Subject: NHTSA NPRM HIII 5F Request for Comments
Docket No. NHTSA-2019-0023

Hybrid III 5th Percentile Female ATD (HIII-5F) Item 1 comments from 2/20/2020:

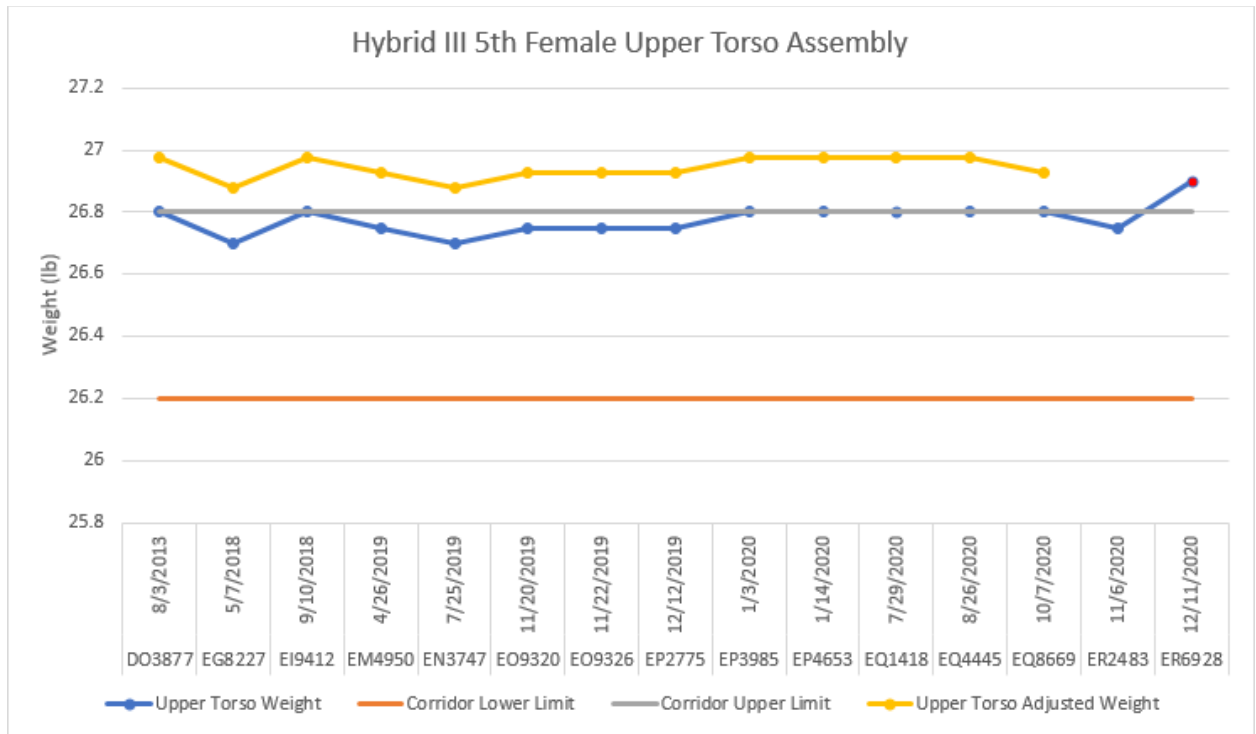
The SAE spine box design, 880105-1045, as proposed in the NPRM adds approximately ~.170 lbs. (~0.077 kg) to the upper torso assembly per SAE J2915. We estimate the design adds ~.178 lbs. when we include the welds. The change in mass has an adverse effect on the upper torso part grouping assembled weight requirement on sheet 6 of the top-level assembly drawing, 880105-000(-H). The mass becomes out of spec above the upper limit of the corridor when the SAE spine box is implemented. The design adds mass to the upper torso roughly 30% of the allowable tolerance. The current weight specification for the upper torso assembly segment is 26.50 +/- .30 lbs.

A review of past mass data from 14 previously shipped ATDs shows the harmonized upper torso data in the upper quarter of the weight specification when fitted with the current spine box, 880105-1000-FT. The graph above shows the upper torso assembly mass for harmonized ATDs in blue and the theoretical adjusted weight if implementing the SAE spine box in yellow. Weight is adjusted by .178 lbs. to reflect the added mass. All 14 harmonized ATDs shipped fail the upper torso assembly weight specification once the mass is adjusted to accommodate the SAE spine box design.

An update to the weight specification for the upper torso assembly is required to implement the SAE spine box as proposed in the NPRM. We request to update the weight specification to represent the population of ATDs currently in the field. The upper torso assembly is comprised primarily of machined and welded components; with the chest jacket providing the bulk of mass due to molded components. It is unlikely there's harmonized ATDs in the lower limit of the weight corridor.

We request an update to Sheet 6 of the top-level drawing, 880105-000(-H), to shift the weight corridor for the upper torso assembly segment to allow for retrofitting of the SAE spine box design into existing ATDs in the field. This update would more accurately capture the existing harmonized population while also mitigating any issues with installing SAE spine box upgrades going forward.

Updated graph of the proposed shifted corridor is shown below

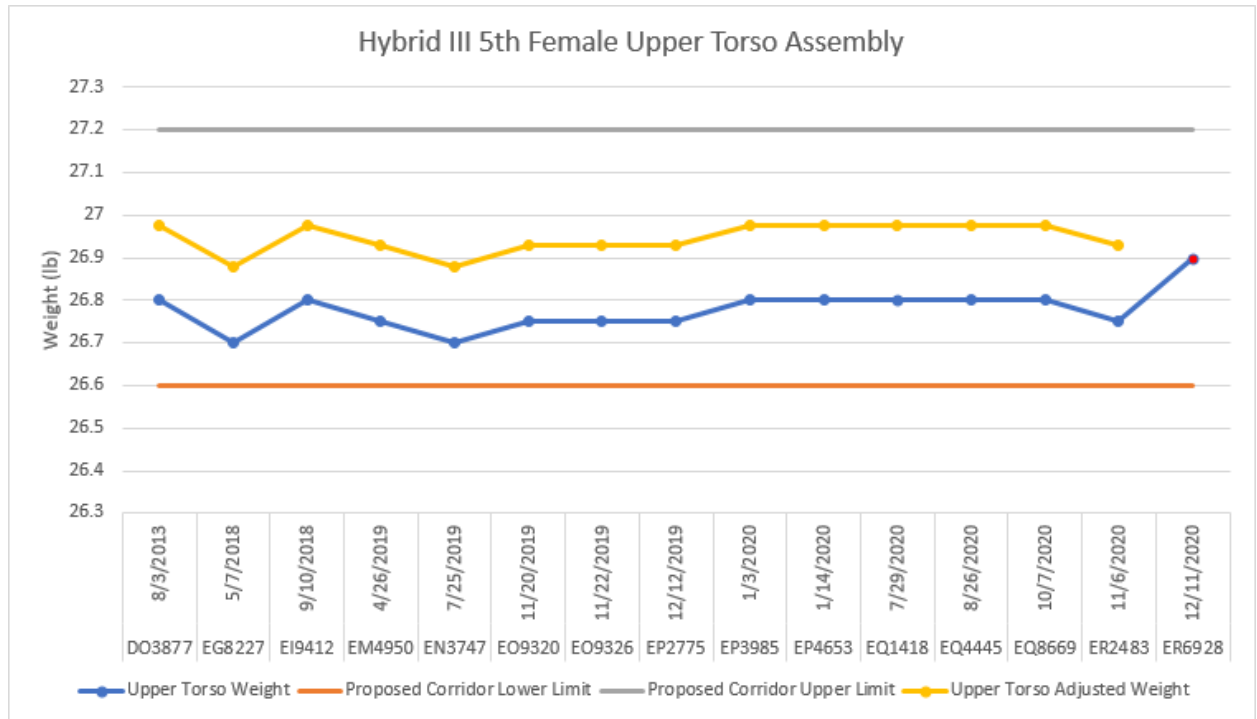
Updates to Sheet 6 assembly weights would include a shift of the nominal weight specification for the upper torso assembly to **26.90** +/- .30 lbs from 26.50 +/- .30lbs. This change will allow the corridor to shift upwards .40 lbs. Approval of this update would also shift the total dummy weight to **108.43** +/- 2.50 lbs. from 108.03 +/-2.50 lbs. (shown below)

Humanetics recommends updating 880105-000(-H) Sheet 6 upper torso assembly segment weight specification to shift the nominal value to 26.90 +/- .30 lbs. and the total dummy weight to 108.43 +/- 2.50 lbs.
